PRODUCT UPGRADE SHEET

LBP 1005 series replaced by LBP 1005SR

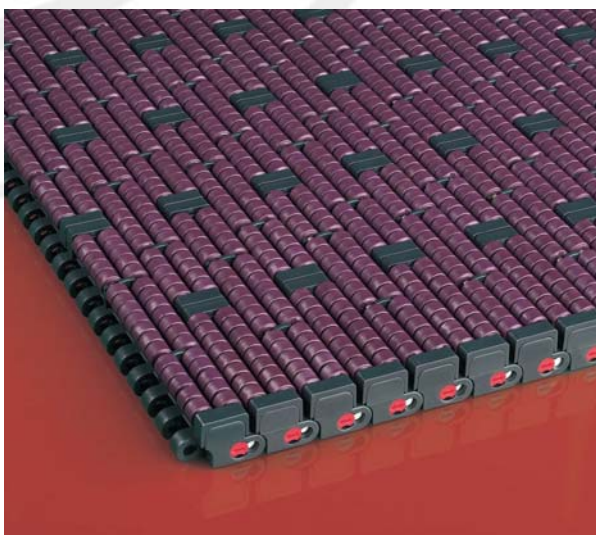
These chains will be replaced by **LBP 1005SR**, giving a **smaller backflex radius** capability. Old and new versions are **fully interchangeable** and can be connected without difficulties. Below is shown a comparison between both chain types; only the minimum possible **backflex radius** is different:

Old version			New version		
Chain type	Code number	backflex radius	Chain type	Code number	backflex radius
LBP 1005 XLA	877.03.xx	300 mm	LBP 1005SR XLA	877.17.xx	120 mm
LBPDP 1005 XLA	877.04.xx	300 mm	LBPDP 1005SR XLA	877.18.xx	120 mm

In the same time Rexnord has improved the friction of the rollers, so now we can offer 25% extra **accumulation length**, with the same pressure on conveyed products as before the change. For example, if with the old version it was possible to make 6m long conveyors, with the new version it is 7.5 meters!

No modification is needed on sprockets; furthermore no changes are necessary to the conveyor.
